Addendum No. 5

Project: Salem Community Schools
2021 FEMA Safe Room Additions

Project No.: 202020.01/02

Date: May 3, 2021

P201A

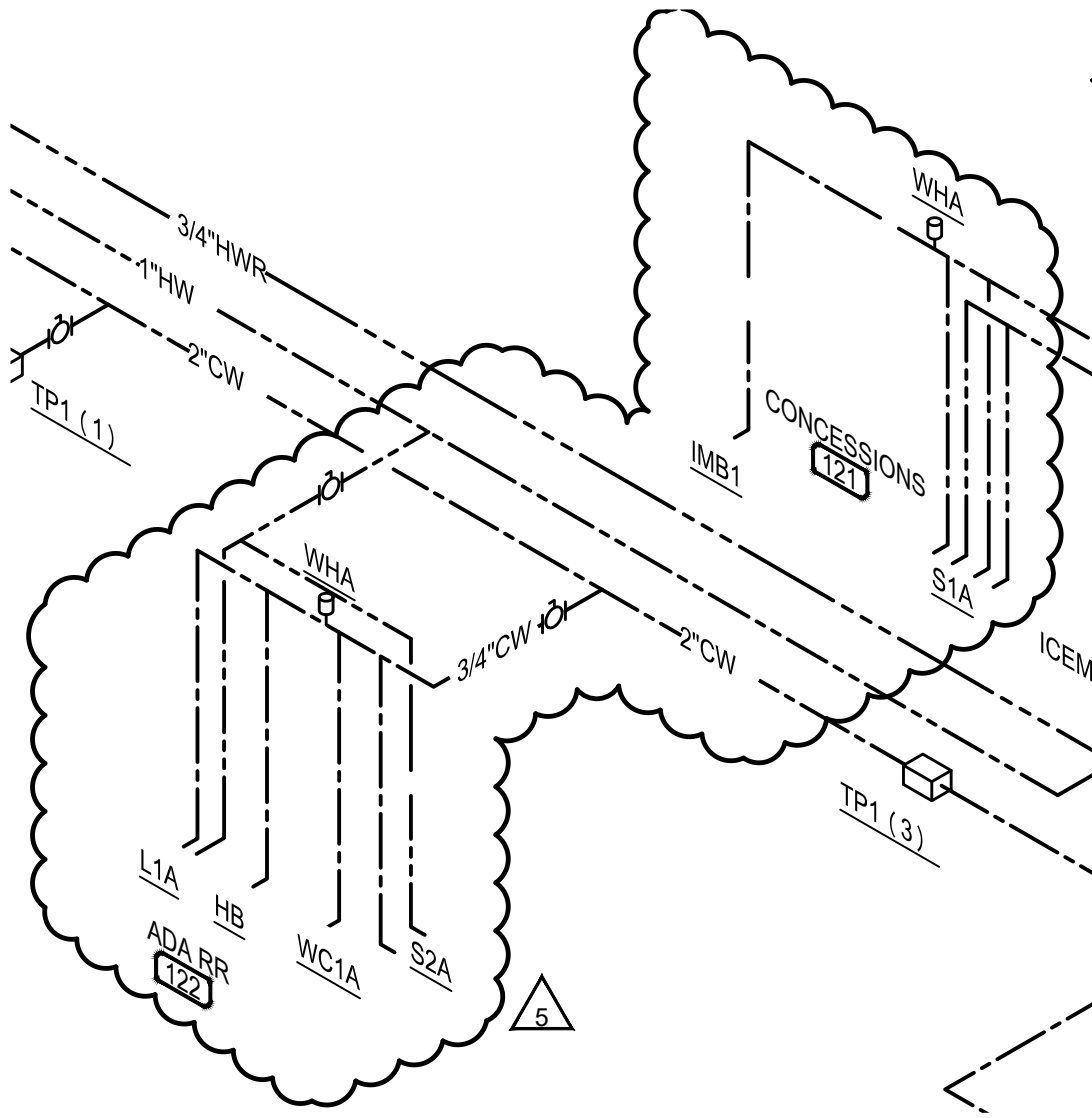
Item 1: Refer to attached Volume 1 revision sketches P101A, P201A, P502A, and P601A

- A. Sink S1A in CONCESSION 121 shall be changed to be a 3-compartment, casework mounted sink as indicated in revised PLUMBING FIXTURE SCHEDULE.
 - a. Sink S1A drain shall be 2" and discharge to floor sink FS1. Route drain line tight to plan North wall, coordinate routing with ice maker and beverage cooler. Slope at 1/4"/foot.
 - b. Coordinate sink installation with casework, refer to architectural plans.
 - c. Provide (2) cold and hot water lines to sink (additional S1A faucet has been added).
- B. Sink S2A has been added.
 - a. Sink S2A shall be wall mounted with the rim at 34". Provide with factory wall mounting bracket per revised PLUMBING FIXTURE SCHEDULE
- C. Floor Drain FD1 has been added in RR113.

M101B

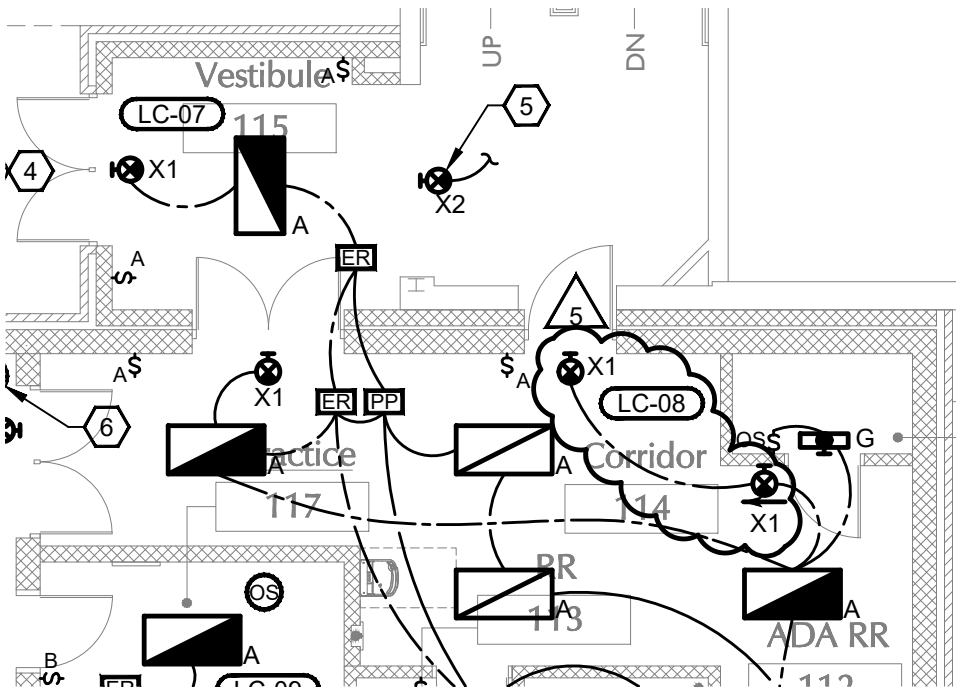
Item 7: Refer to attached Volume 1 revision sketch M101B

- A. Revise HP-5 / CHOIR 101 return ductwork routing as indicated on this sketch.

E101B

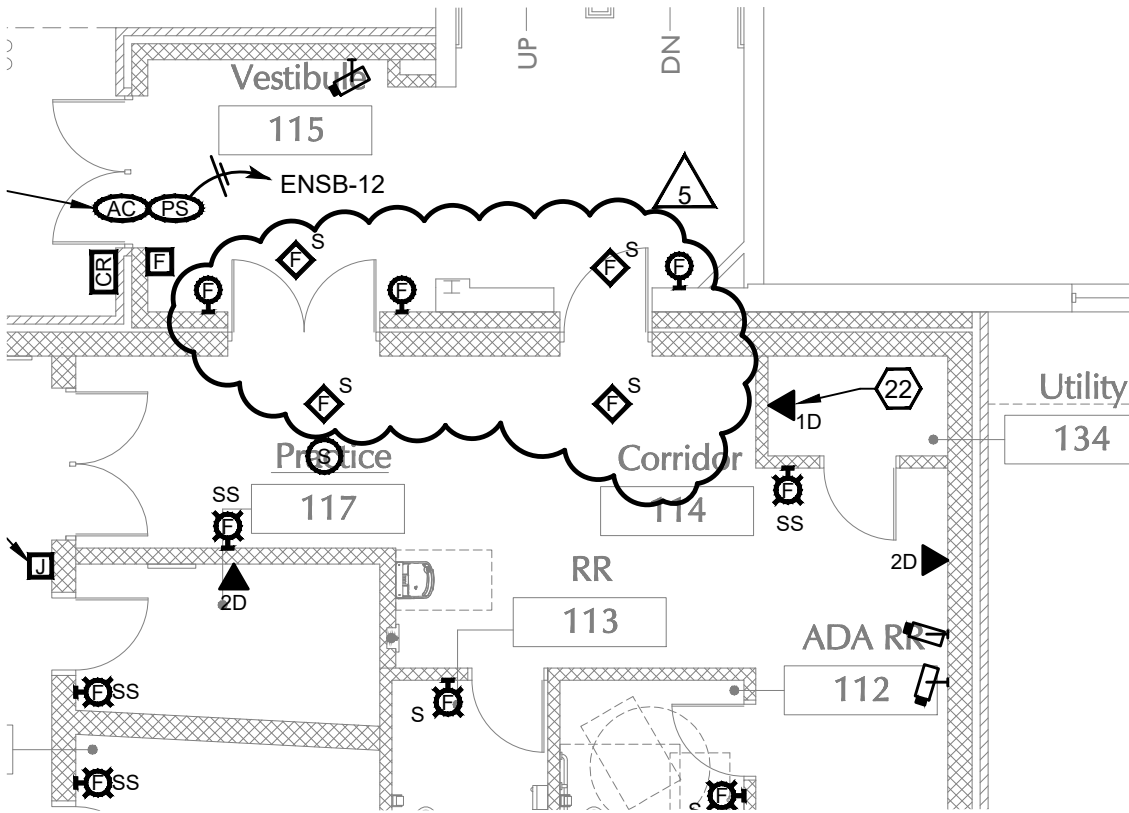
- A. Refer to attached sketch E101b. Add Exit Sign type "X1" above door 114 leading out of Corridor 114.

E301C

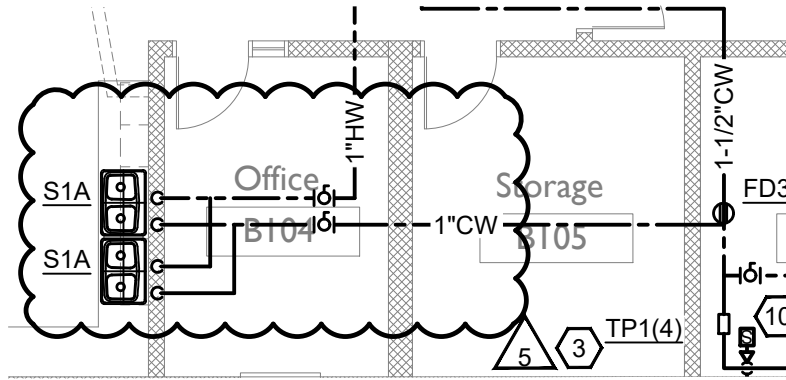
- A. Refer to revised sketch E301C.
 - a. Provide magnetic door hold opens with extension brackets as required for 90-degree door swing and smoke detectors on each side of door 115b. Coordinate requirements with all trades prior to installation.
 - b. Provide magnetic door hold open with extension bracket as required for 90-degree door swing and smoke detectors on each side of door 114. Coordinate requirements with all trades prior to installation.

P201A

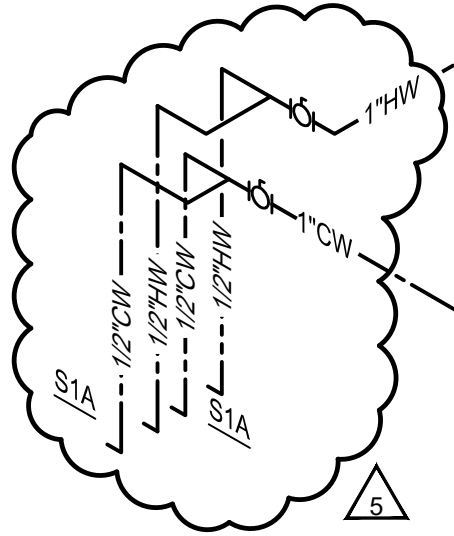
Item 2: Refer to attached Volume 1 revision sketches P101A, P201A, and P502A.

- A. Additional sink S1A shall be added in PREP AREA B103.
 - a. Provide plaster trap for S1A sink that has been added.
 - b. Coordinate sink installation with casework, refer to architectural plans.

P502B

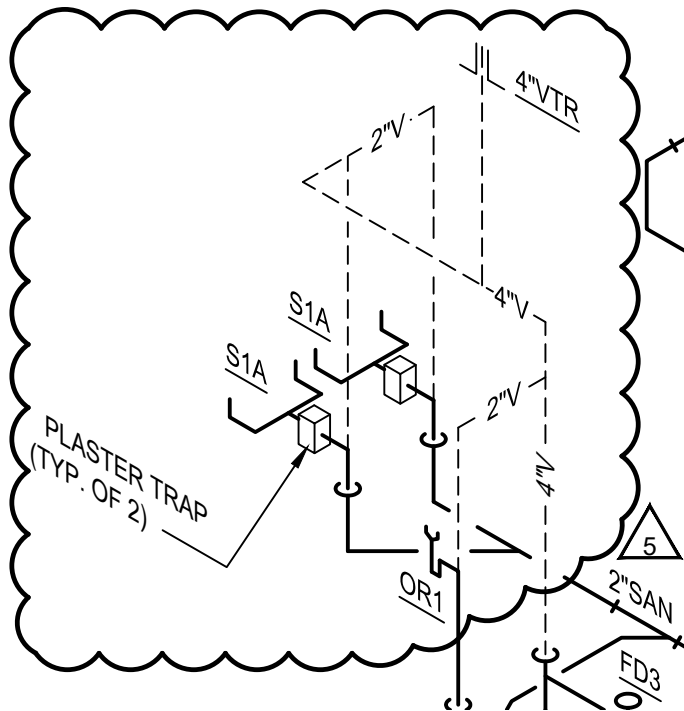
26. Drawing P101: The electric water cooler outside of Custodian B111 is "EWC1A".
27. Drawing P502: Add EWC1A to sanitary and domestic water riser diagrams. See Plumbing Schedule for piping sizes.
